**Seattle
Public
Utilities**

Seattle Design Commission Presentation: October 7, 2021

Ballard Pump Station

Schematic design recommendations: SPU responses

Schematic Design Recommendations

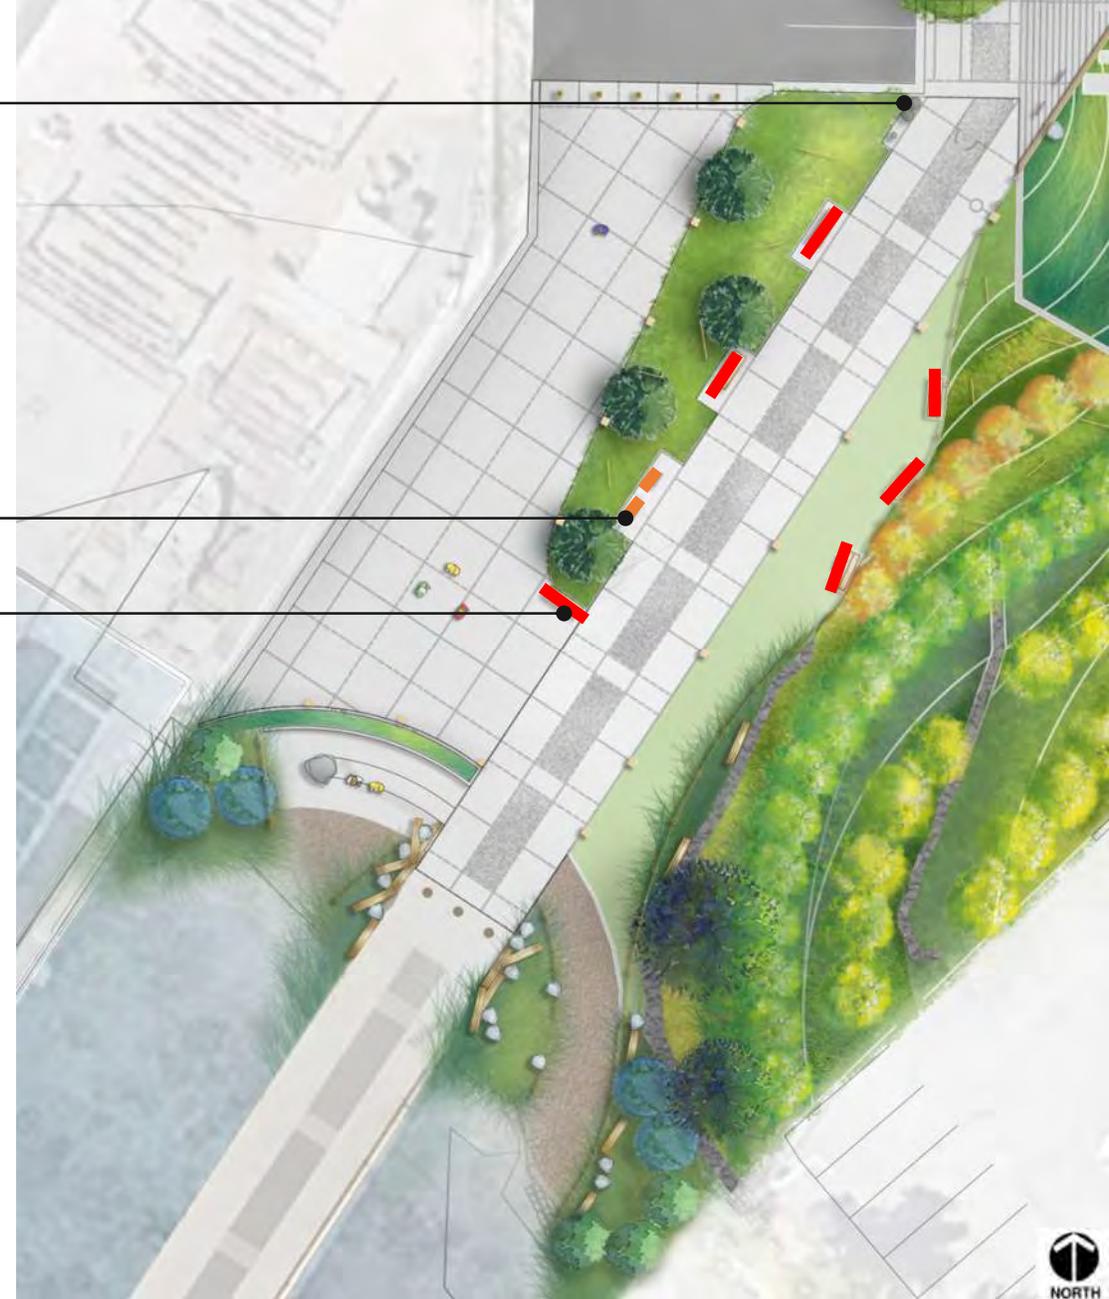
5. Thoroughly consider **parking needs** and maximize **pedestrian and recreational use** of the shoreline right of way. Provide for **temporary community programming**.
6. Consider providing more **amenities** that support full use of what will be a busy access point to the water, including bike parking, locking stations for kayaks / paddle boards, and sufficient trash and recycling areas.
7. Provide enough **seating with backs** and side rails to meet the needs of the older people in this community.

Trash, recycle, and dog waste receptacles

Bike racks

Large wood timber benches (with backs)

Schematic Design Recommendation

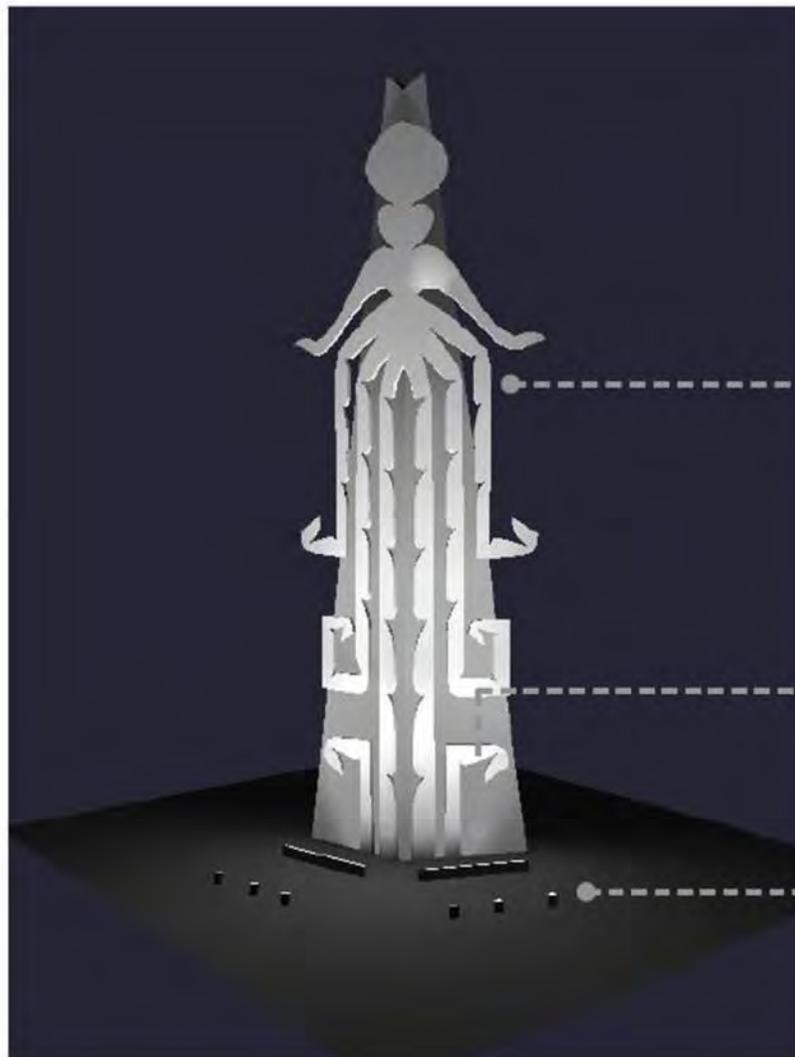
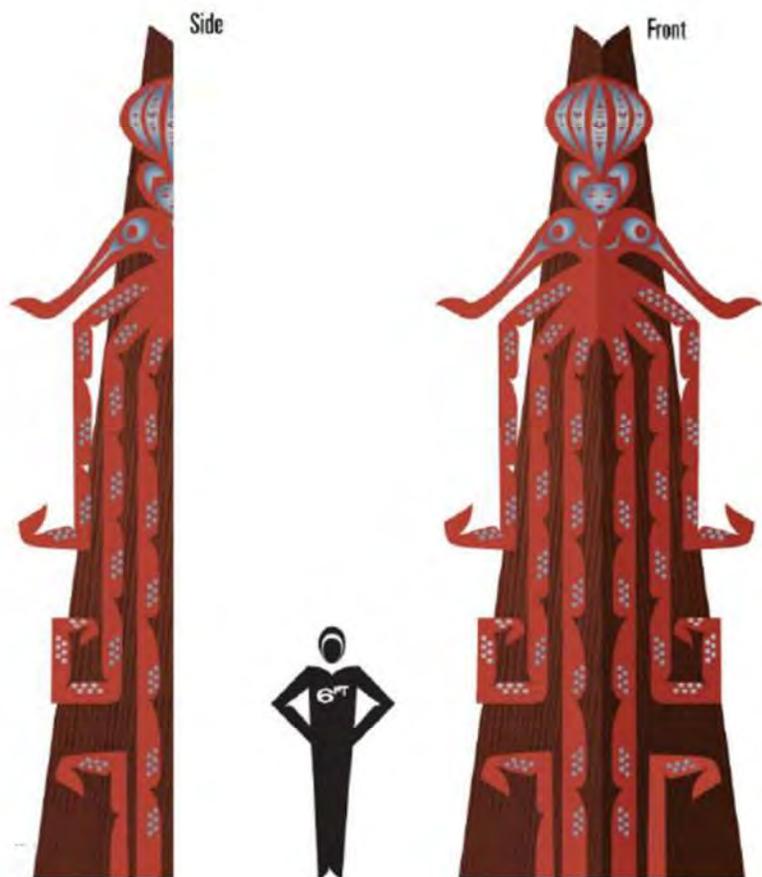
8. Consider **ambient light**, the multitiered and sided characteristic of the art, and the pedestrian perspective. Concern lighting might be **too bright for the surroundings** and could distract immensely from the art.

Soft gradient of light rising up from the base of the artwork.

Linear uplights to illuminate the base of the artwork

Aimable point source fixtures to push light up the face of the artwork.

Schematic Design Recommendation

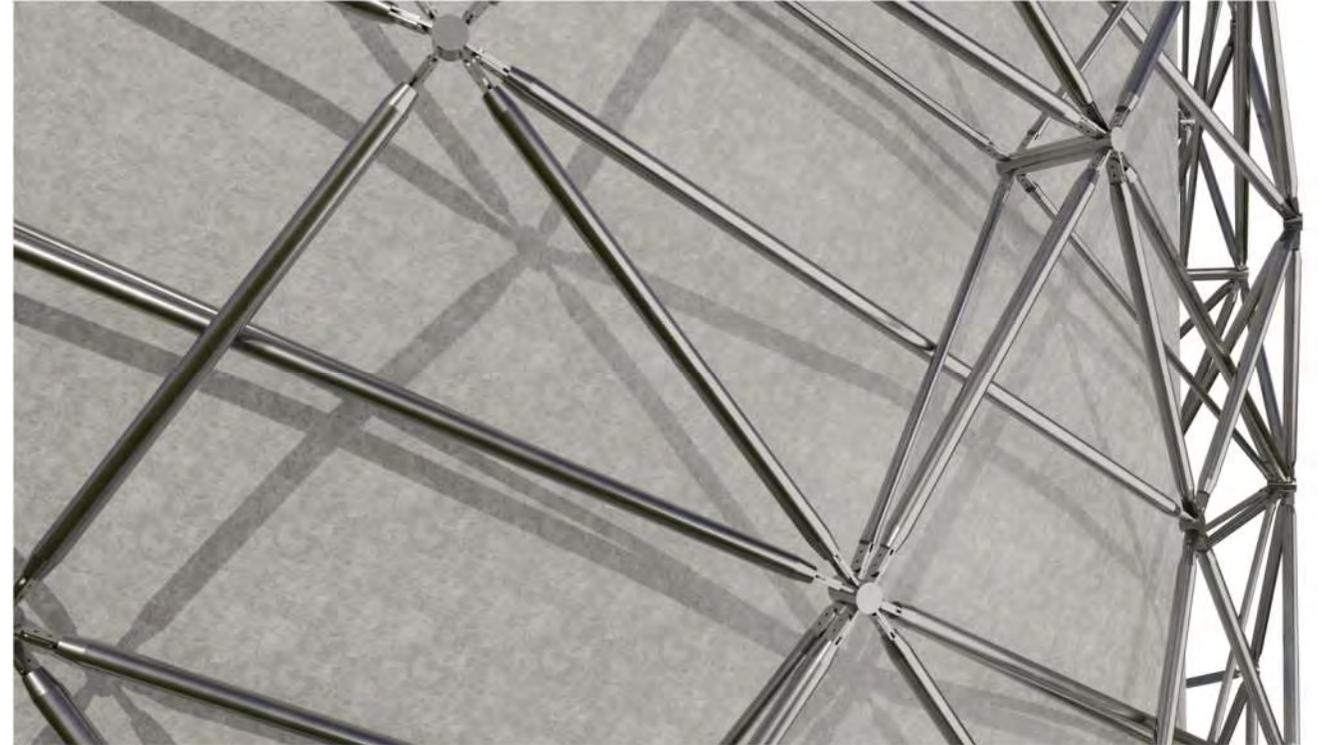
9. Consider a more **permeable, transparent material** for the fence.

FENCE AND ANCILLARY EQUIPMENT
